**Application APP/20/0990 - Havant Thicket Reservoir
Application to Havant Borough Council for approval of a Non Material Amendment**

Background to the Non Material Amendment

Extract from Illustrative Planning Strategy Key Plan to show design evolutions

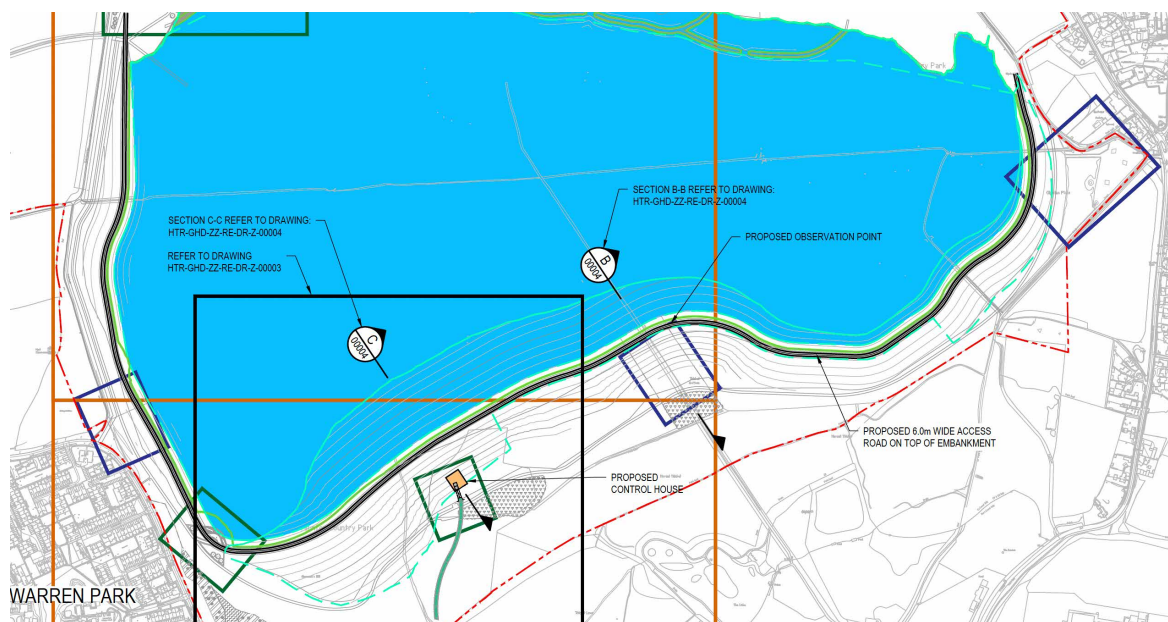
Revised southern embankment position :

- o southern (external) toe moved further north near to the retained Ancient Woodland (away from the woodland by up to 45m – maintaining minimum 25m separation from the ancient woodland), and extended south in the south-west corner (to the west of the culvert and control house location)
- o northern (internal) toe moved further north as a consequence of the above by a variable distance
- o crest moved further north by up to 45m and extended in length to approximately 2,830m

Slight increases to excavation and embankment earthworks volume, and small reduction in reservoir capacity but minimum capacity maintained at above 8,700 Million litres

The embankment profile / gradients (both internal and external faces) remain as per the Hybrid permission (1:5 to 1:7 slopes)

In addition, as a result of the proposed earthworks embankment changes, other consequential changes will arise, with the location of the Culvert, Valve Tower, Control House, Avenue Staircase and Viewing Platform moved to the north (by virtue of the embankment moving north).

The Figure below provides an illustrative update to the Planning Strategy Key Plan approved as part of the Hybrid permission, with the extract focused on the southernmost embankment to illustrate the design evolutions identified above.
